# Product / Process Change Notification

N° 2020-176-A

**Capacity expansion with introduction of an additional assembly and final test location at Huayi Microelectronics Co., Ltd (HYME), China for dedicated TO220 3L MOSFET products in Gen 5.X/7.X/10.X**

**Marking on device:**

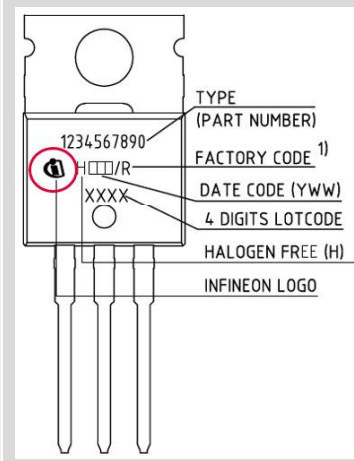
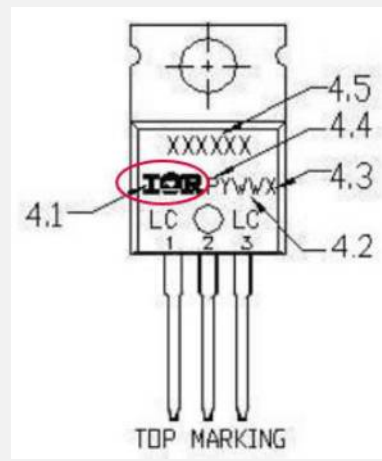
- Legacy International Rectifier (IR) logo

- Legacy Infineon logo
- Note: Existing there are slight variations in the marking layout across different production site.

Note: Lot code ("R") is used to identify production done at HYME
